Technical Bulletin # 1153

Transmission: *AW55-50SN (AF33-5)*

Subject: *2-3 Flare or Bump*

Issue Date: *February, 2008*

Fig. 1 Broken Washer in B4 Band Servo Cover

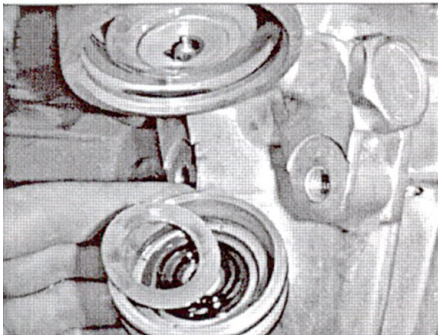
Some Volvo models with the 5-speed AW55-50SN (AF33-5) transmission may have a bump or flare on the 2-3 shift. Some owners may also complain about a harsh 4-3 downshift. This can be caused by a broken washer on the B4 band servo cover. See Fig 1. A new cover assembly (30651771) is available to correct this concern.

Fig. 3 Clean area around Servo Cover and Snap Ring

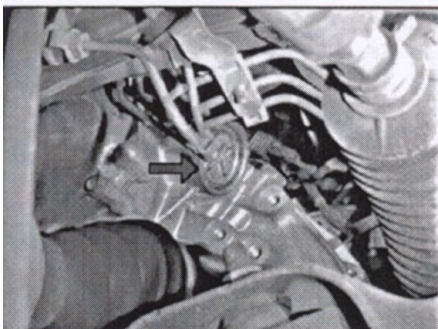
Use care when removing and installing the band cover. See Fig. 3. Pry the cover inward. Clean the area around the snap ring and spray penetrating oil to help free parts. See Fig. 3. Remove the snap ring, servo cover and servo. See Fig. 4.
